# Value Engineering Study

## Kentucky Transportation Cabinet

KY 15, Breathitt County Major Widening

Item No. 10-376.00

**SKETCH/DIAGRAM: VALUE PROPOSAL**

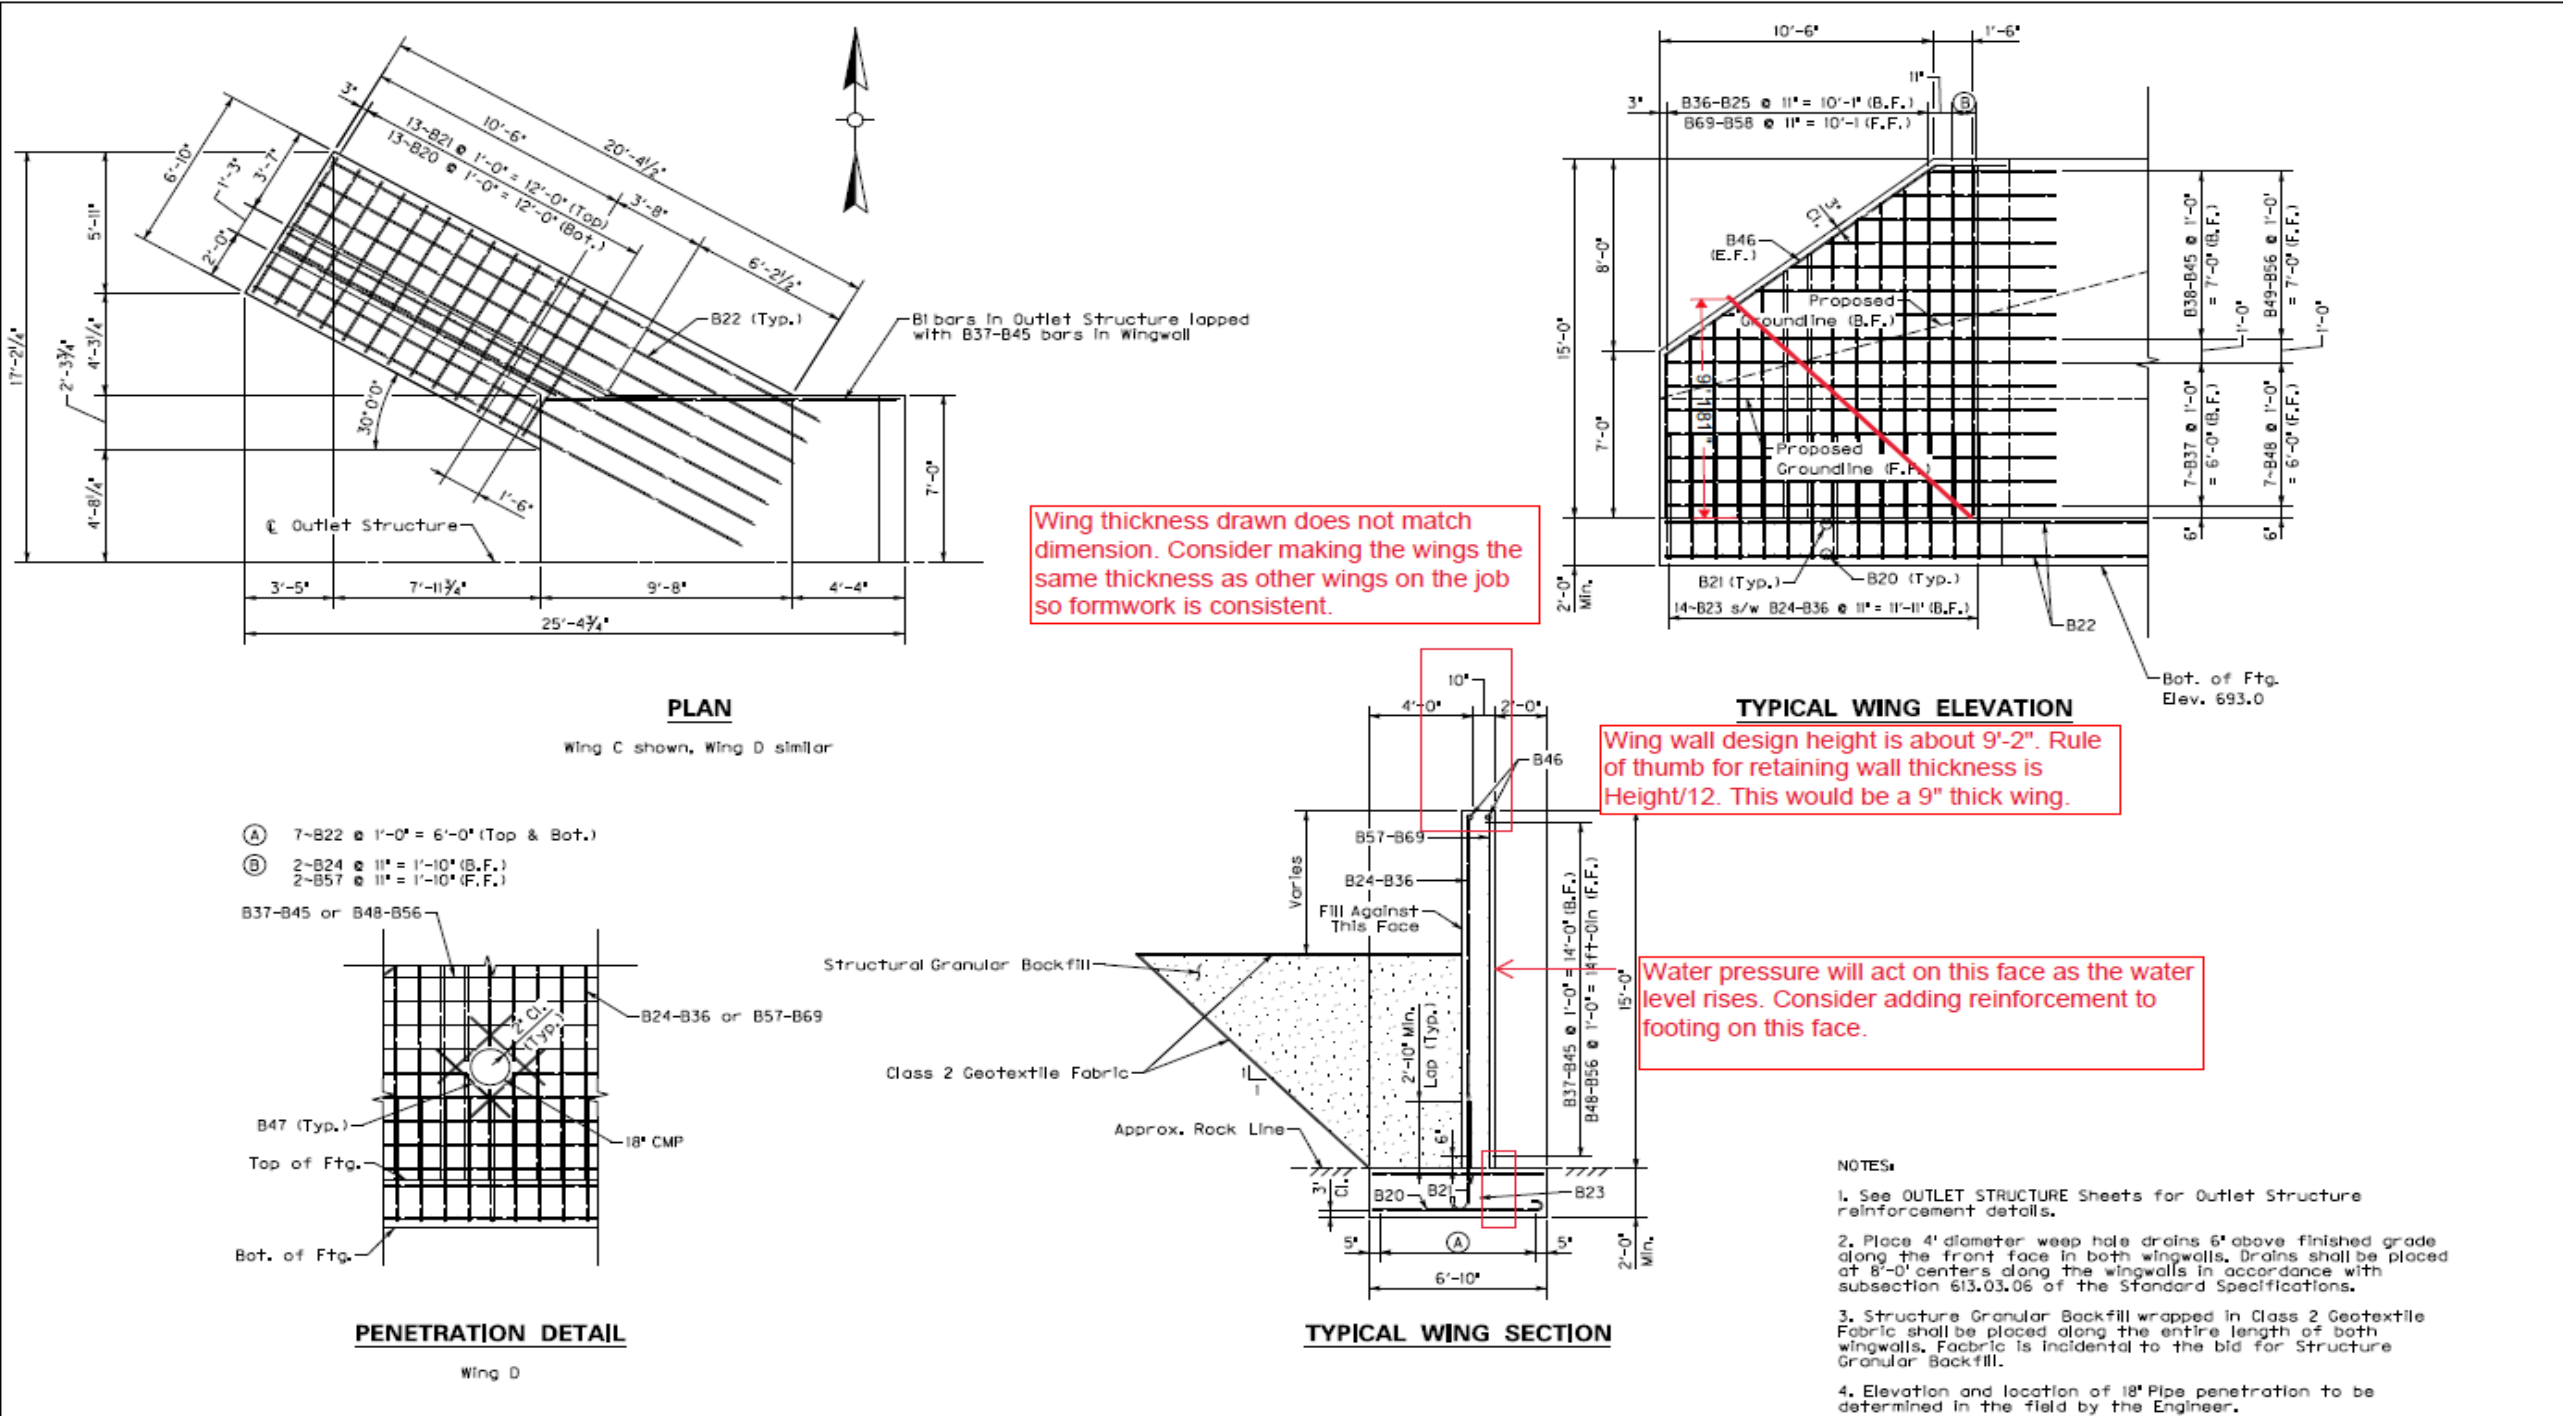
Wing thickness drawn does not match dimension. Consider making the wings the same thickness as other wings on the job so formwork is consistent.

Wing wall design height is about 9'-2". Rule of thumb for retaining wall thickness is Height/12. This would be a 9" thick wing.
